Landscape Response to post-application comments

Outline Planning Application for 200 dwellings on Land at Foxhole Lane, Bolney (Ref: DM/25/1129)

Date: 4 July 2025

Figure 2: Year 1 Photomontage from footpath 44Bo.

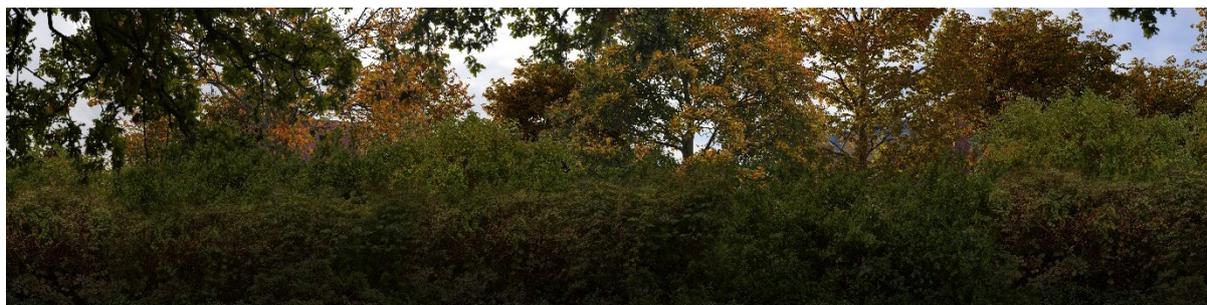
2.1.9 Paragraph 2 on page 5 of Place Services comments state “*we remain concerned regarding the impact on the visual amenity of the Public Right of Way given the proximity of built development to the boundary and the function of the PRoW as the approach and departure of the conservation area where the existing landscape features and open countryside views provide the transitional landscape.*” Paragraph 3 states “*setting back the development envelope further from the northern boundary to allow for a more open character will better support Policy DPA14 which requires the development of the site to “Retain the character of footpath 44Bo”*”. In response to both of these points, footpath 44Bo is currently primarily enclosed by hedgerows and trees and views out only occur where the hedgerow along the northern boundary is breached (i.e. as a result of the localised poor condition of a valued landscape element). As noted above, the landscape management guidelines for both LCA HW4 and LCA10 recommend that hedgerows should be managed and replanted where they have been damaged/lost, and for this reason, it is proposed the hedgerow along the northern boundary will be reinstated. In addition, the following design strategies have also been implemented in the locality of the footpath: and therefore, the following strategies and features have been incorporated along this edge:

- Built form has been set back by a minimum of 16m and a landscape buffer of native tree and shrub planting incorporated within this margin;
- Semi-mature trees, which would be planted as light standards (2.5-3m), have been incorporated to filter views of built form; and
- Hedgerows are proposed as garden boundary treatments rather than fencing or walls to reduce the potential extent of built form in the view.

- We would also be willing to explore the option of the reinforcing hedgerow planting along the northern boundary commencing within the first phase of works to allow for 2-3 years of growth before the northern parcel is constructed. This would further reduce visual effects on users of this footpath and sooner “retain the character of footpath 44Bo”.
